Reliability Analysis Update

Transmission Expansion Advisory Committee
May 8, 2026

- 2026 RTEP - Window 1
 - Schedule Update
- 2025 RTEP - Window 1
 - P5 Updates
- Scope / Cost Changes
- NJ SAA Project Cancelations

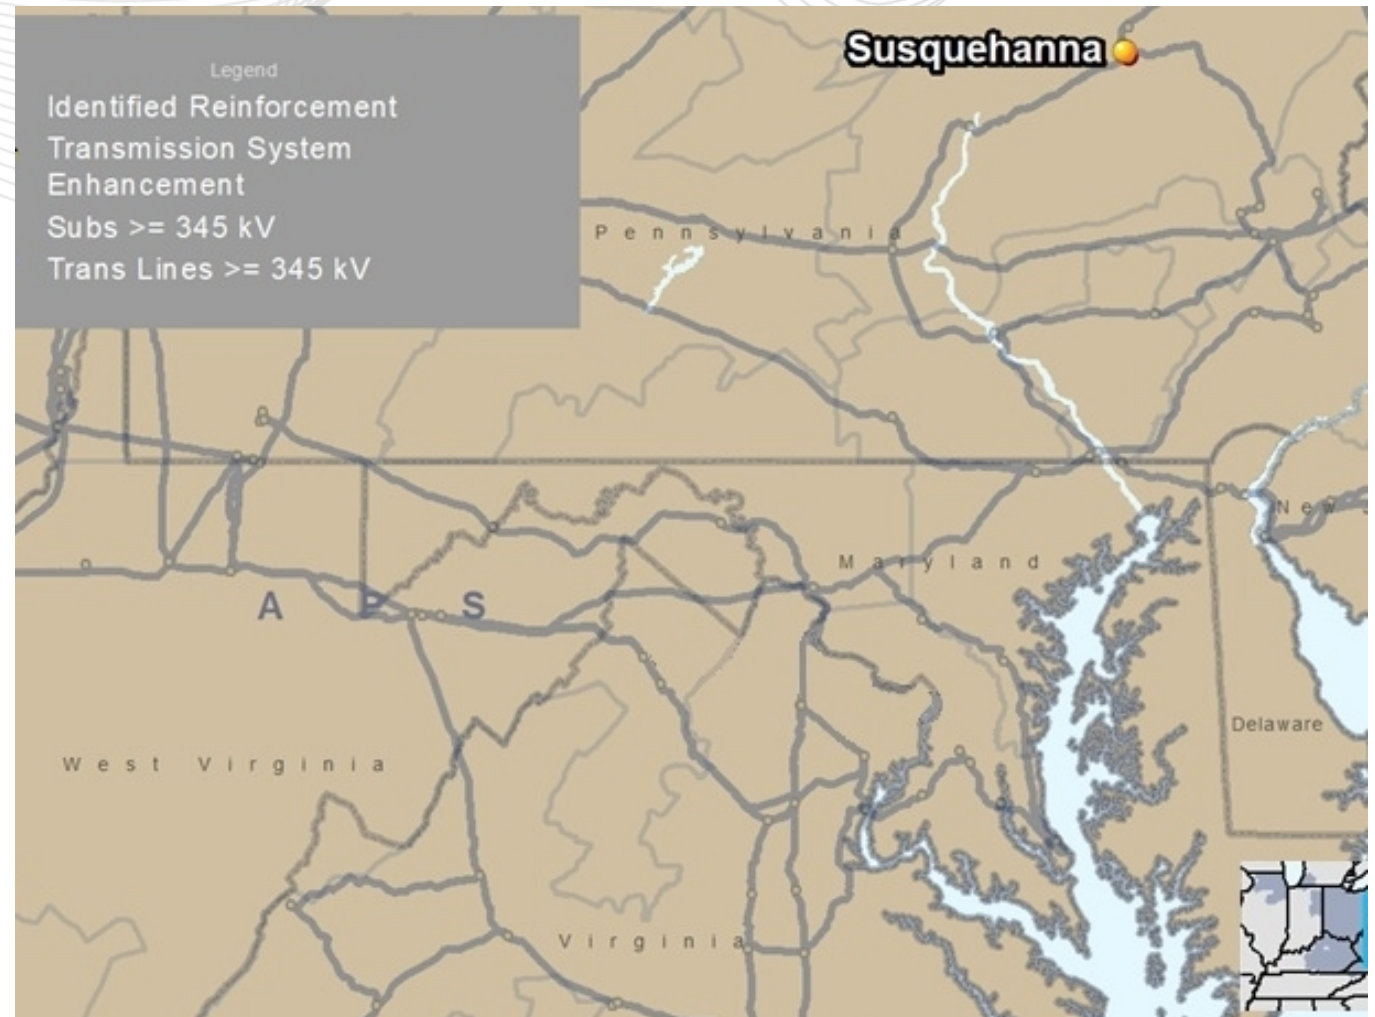
In the 2030 RTEP Short Circuit base case that includes the PPL cluster selected solution, 2025-W1-558 + Component from 2025-W1-853 (Kelayres 3rd 500/230 kV transformer), which was presented in 12/8/2025 TEAC, six 230KV breakers at Susquehanna were identified to be over duty.

Replace the six 230KV breakers at Susquehanna ,**due to fault current rating increase to 63kA. Replace the bushing current transformers of five 230 kV circuit breakers. Perform substation ground grid mitigation. (B4029.18)**

Estimated Cost: ~~\$4.50M~~ **\$7.39M**

Scope Change for b4000.344 & b4000.345 (500kV Line North Anna – Thornburg⁽¹⁾ (formerly Kraken) - Bristers):

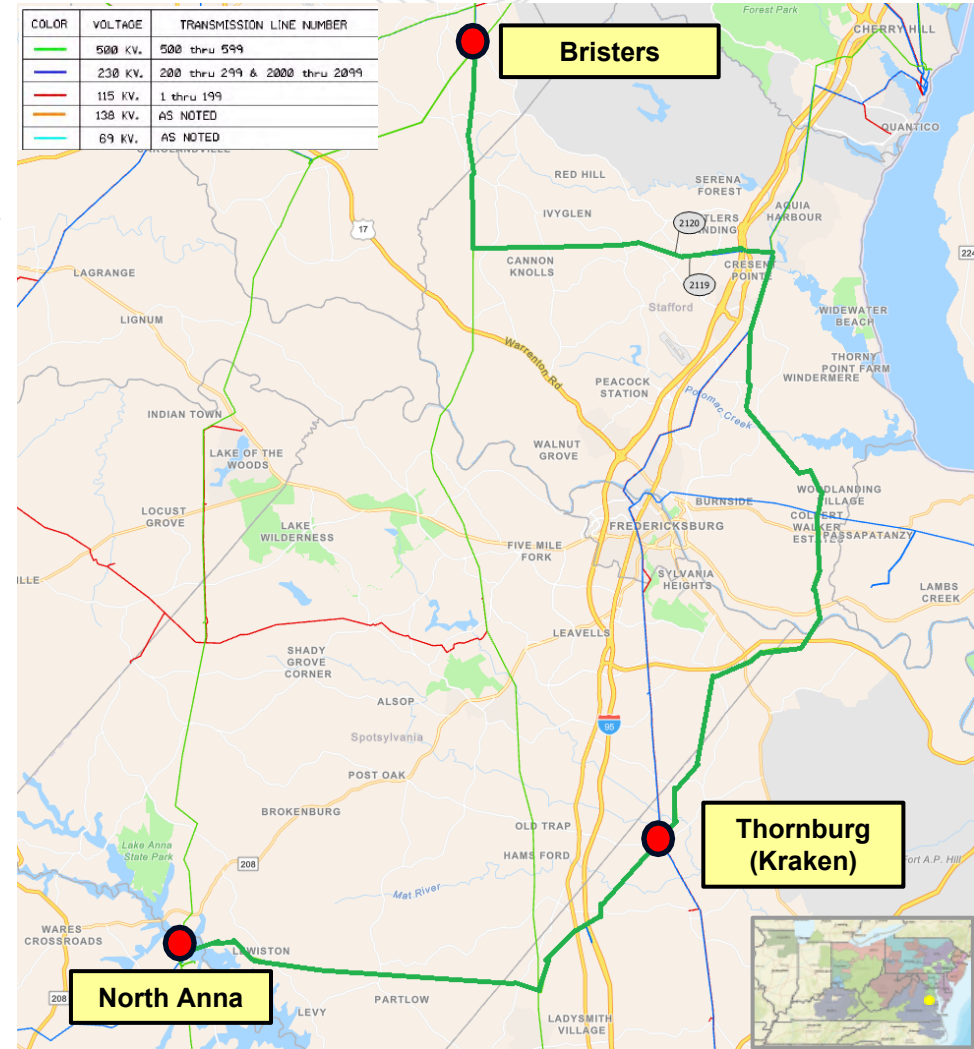
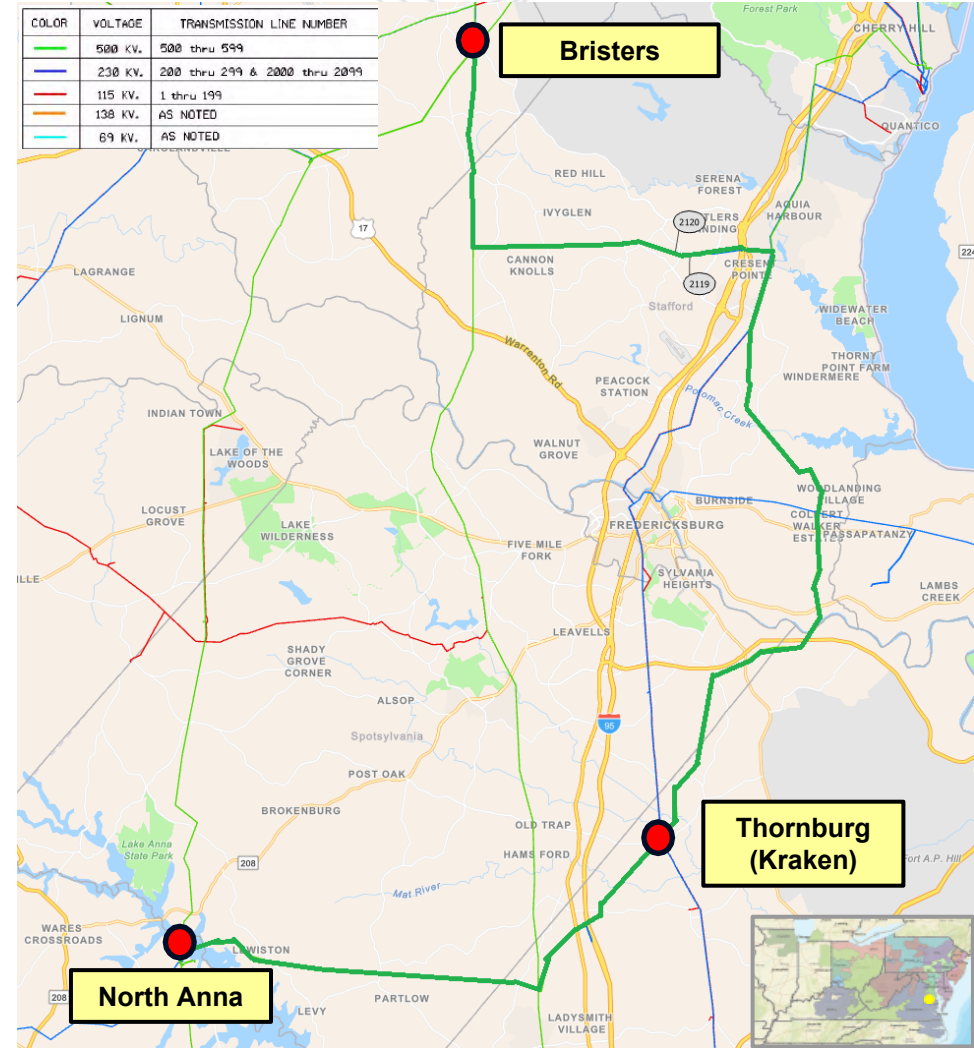
- Switch to 5/2 structures for the transmission line from North Anna – Thornburg (aka Kraken) – Bristers, with a designated 0.36-mile segment from Stafford to Aquia Harbor constructed using 5/5 structures.

- The general area within proximity of the corridor North Anna - Thornburg - Bristers has experienced load growth, mainly data centers, since proposing this project during the 2024 RTEP Open Window 1.
- The inclusion of 230 kV underbuilt capability enables reuse of existing structures, minimizes future environmental impacts, long-term capital costs, and avoids extended outages on critical 500 kV facilities.

Additional Cost Estimate: \$90M (b4000.344 \$29.5M + \$60.5M b4000.345)

Total Proposed Cost Estimate: \$661.63M

Revised In-Service Date: 9/16/2030

Scope change for B4000.355 – B4000.359 (New Yeat – Joshua Falls 765kV line, Yeat 765/500/230kV Substation)

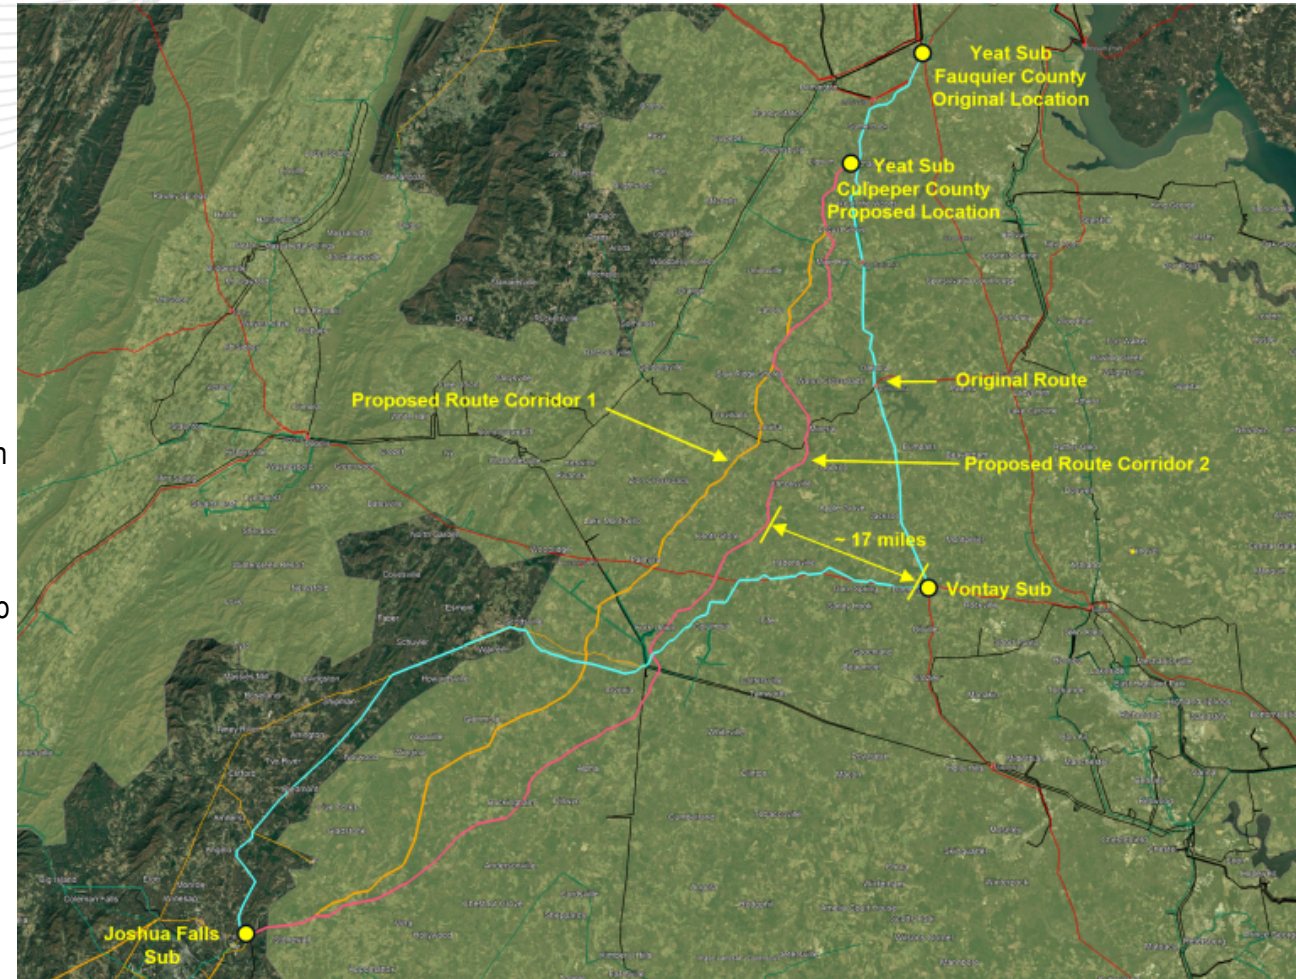
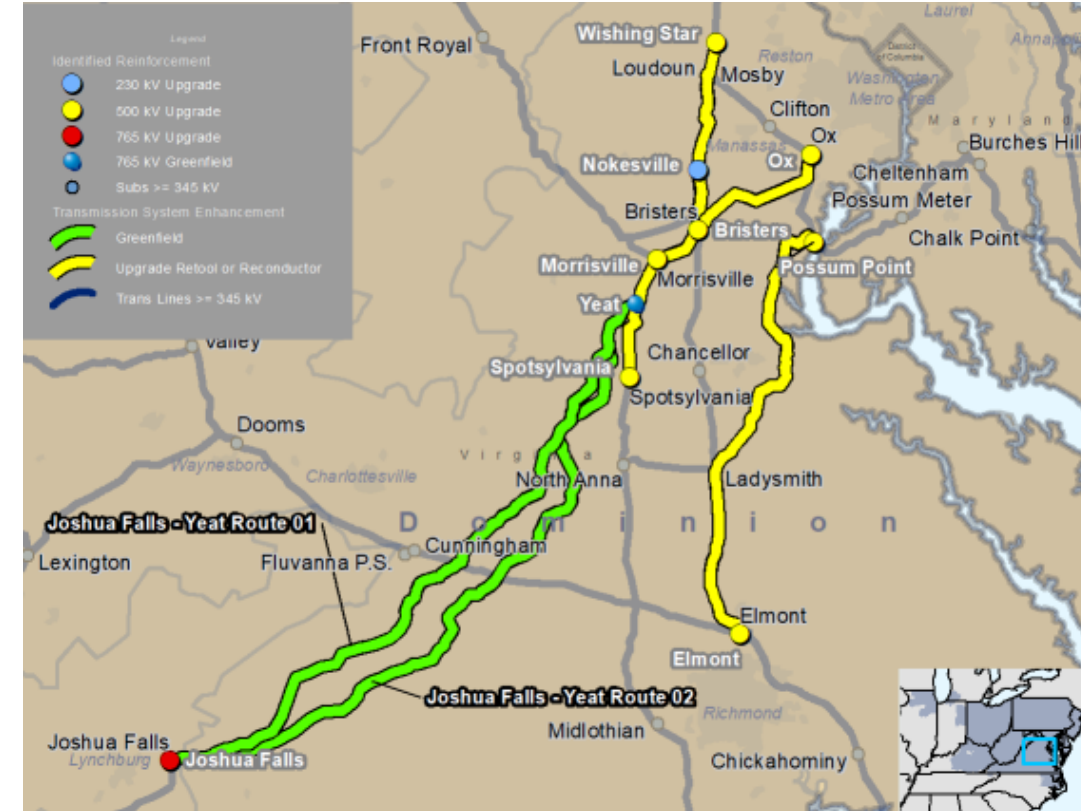
- Relocate Yeat 765kV substation further south by ~15 mi
- Reduce (shorten) Joshua Falls – Yeat 765kV greenfield line to 115 miles
 - 765kV line will head directly towards Yeat (N-E direction from Joshua as shown in map and will no longer pass by Vontay)
- Remove 230kV yard at Yeat
- Cut-in Culpeper Yeat into 500kV Line #594 Spotsylvania - Morrisville
- Extend Morrisville - Wishing Star 500kV line by 7.5 mi from Morrisville to Culpeper-Yeat (using existing ROW)
- Move Kraken loop 500 kV line termination to Bristers (Previously Yeat), reducing length by 1.5 mi

- Rebuild ~8 miles of existing 500kV Line #594 from Yeat to Morrisville
- Tie the Morrisville – Bristers and Bristers – Nokesville 230kV lines by removing line terminations at Bristers (bypassing the Bristers substation)
- Upgrade Bristers 230/115kV transformer
- Revise the Yeat – Ox 500kV line (~21 mi) rebuild scope from 2025W1 (b4053.23) to rebuild Bristers – Ox 500kV line (~23 mi) (~2 mi extra)
- Tie the Elmont – Kraken and Kraken – Possum Pt 500kV lines by removing line terminations at Kraken (bypassing the Kraken substation)
- Rebuild 500kV Line #594 Spotsylvania to Yeat 500kV line (~11 mi)

- Build a new 500kV line from ~~Morrisville~~ **Culpeper Yeat** to Vint Hill. New conductor to have a summer rating of 4357 MVA. Line length is approximately ~~49.74~~ **27.21** miles. **(b3800.357) \$101.89M-\$150.64M**
- ~~Upgrade and install equipment at Morrisville substation to support the new 500kV conductor termination.~~ Terminal equipment at Morrisville substation to be rated for 5000 A for 500kV Line #545 & #569. Upgrade 500 kV bus 2 to 5000 A. **(b3800.346) \$17.54 \$12.54**

- Build a 500kV line from a new substation called Kraken to ~~a new substation called Yeat~~ **Bristers**. New conductor to have a minimum summer normal rating of 4357MVA. **(b4000.345) \$394.71M-\$384.96M**

- Cut-in 500 kV line from Kraken substation into **Yeat Bristers** substation **(b4000.346) \$5M (No cost change)**
- Build a new ~~156~~ **115** mile 765kV line from Joshua Falls – **Culpeper** Yeat. (Roughly ~~69.3~~ **1** mile in AEP section). **(b4000.355) \$341.17M-\$24.62M**

- Build a new ~~156~~ **115** mile 765kV line from Joshua Falls – **Culpeper** Yeat. (Roughly ~~86.7~~ **114** miles in Dominion section). **(b4000.356) \$426.83M-\$541.54M**

- Build a new ~~765/500/230kV~~ **765/500kV** substation called **Culpeper Yeat**. Install (2) 765/500 kV transformers. Cut in 500kV line ~~Bristers—Ox and 500kV line Meadowbrook—Vint Hill~~ **Spotsylvania – Morrisville** into Yeat. **(b4000.357) \$197.10M-\$187.10M**

Canceled Projects – JCPL Proposal 453

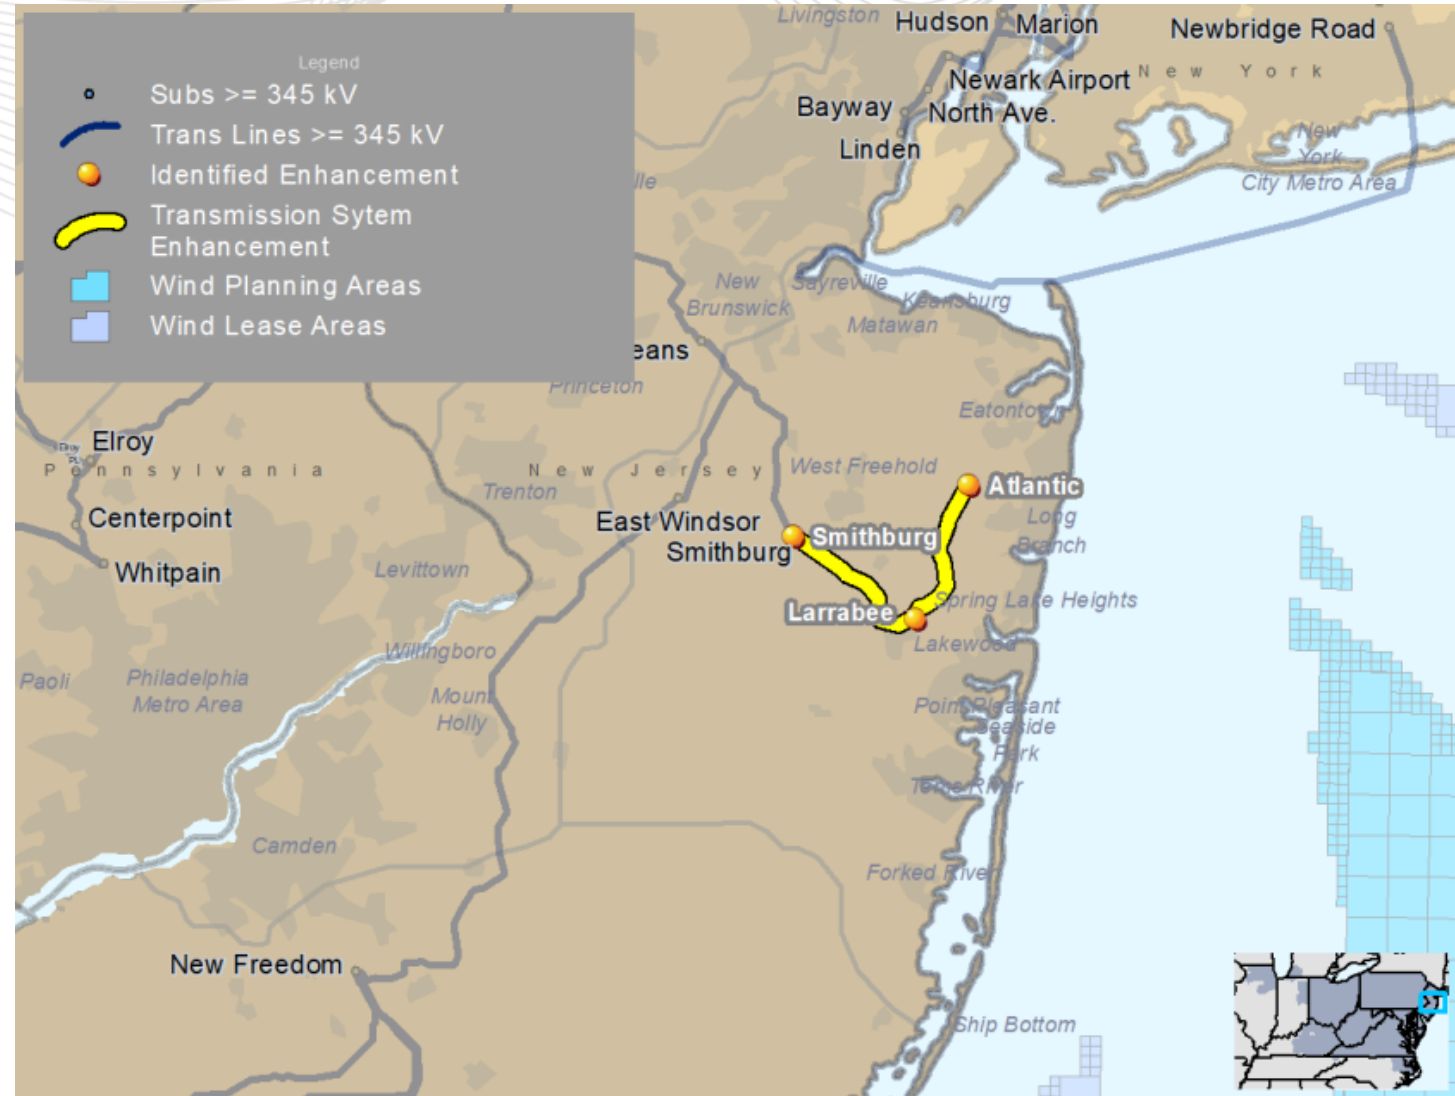
- Larrabee Substation - 230 kV equipment for direct connection (b3737.2)
- Lakewood Generator Substation - Update relay settings on the Larrabee 230 kV line (b3737.3)
- B54 Larrabee-South Lockwood 34.5 kV line transfer (b3737.4)
- Larrabee Collector Station-Larrabee 230 kV new line (b3737.5)

- Larrabee Collector Station-Smithburg No. 1 500 kV line (b3737.6)
- Rebuild G1021 Atlantic-Smithburg 230 kV line between the Larrabee and Smithburg substations as a double circuit 500kV/230kV line (b3737.7)
- Smithburg substation 500 kV expansion to 4 breaker ring (b3737.8)
- Rebuild Larrabee-Smithburg No. 1 230 kV (b3737.32)
- Remove the existing E83 line 115 kV (not in-service) to accommodate the new 500 kV/230 kV lines (~ 7.7 miles) (b3737.53)
- Remove the existing H2008 Larrabee-Smithburg No. 2 230 kV to accommodate the new 500 kV/230 kV lines. (b3737.54)

Canceled Projects – JCPL Proposal 453 (contd):

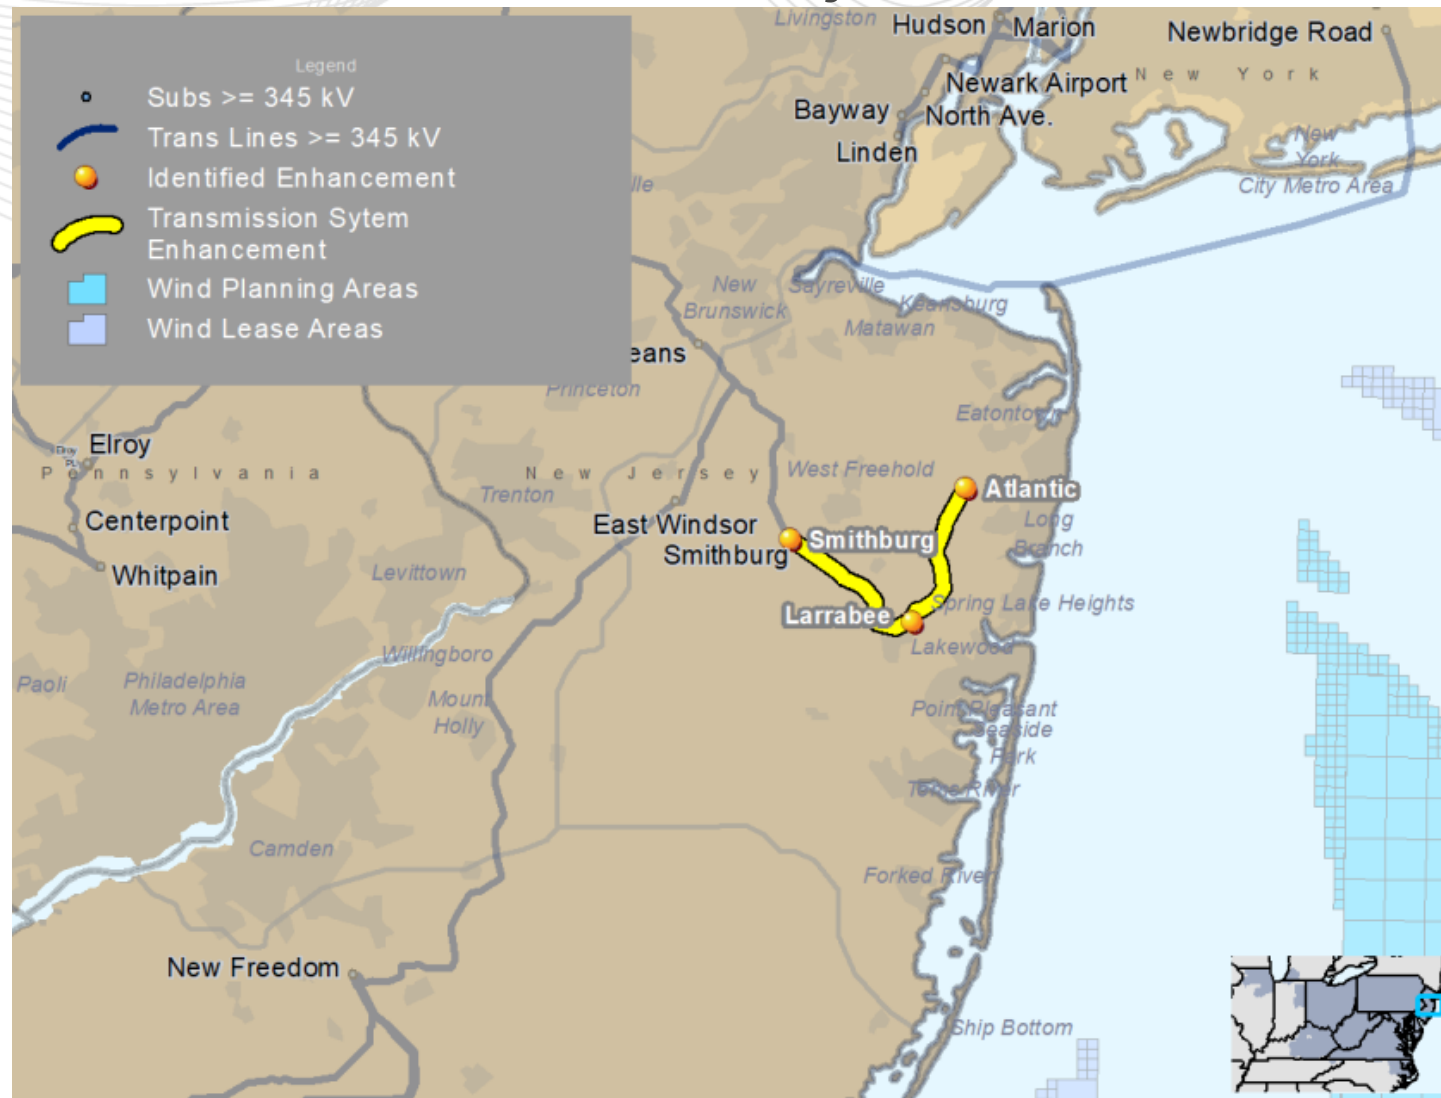
- Larrabee substation upgrades (b3737.9)
- Atlantic 230 kV Substation - Convert to double-breaker double-bus (b3737.10)
- Freneau Substation - Update relay settings on the Atlantic 230 kV line (b3737.11)

- Smithburg Substation - Update relay settings on the Atlantic 230 kV line (b3737.12)
- Oceanview Substation - Update relay settings on the Atlantic 230 kV lines (b3737.13)

- Red Bank Substation - Update relay settings on the Atlantic 230 kV lines (b3737.14)
- South River Substation - Update relay settings on the Atlantic 230 kV line (b3737.15)

- Larrabee Substation - Update relay settings on the Atlantic 230 kV line (b3737.16)
- Atlantic Substation - Construct a new 230 kV line terminal position to accept the generator lead line from the offshore wind Larrabee Collector Station (b3737.17)

- G1021 (Atlantic-Smithburg) 230 kV upgrade (b3737.18)
- R1032 (Atlantic-Larrabee) 230 kV upgrade (b3737.19)
- New Larrabee Collector Station-Atlantic 230 kV line (b3737.20)

- Larrabee-Oceanview 230 kV line upgrade (b3737.21)
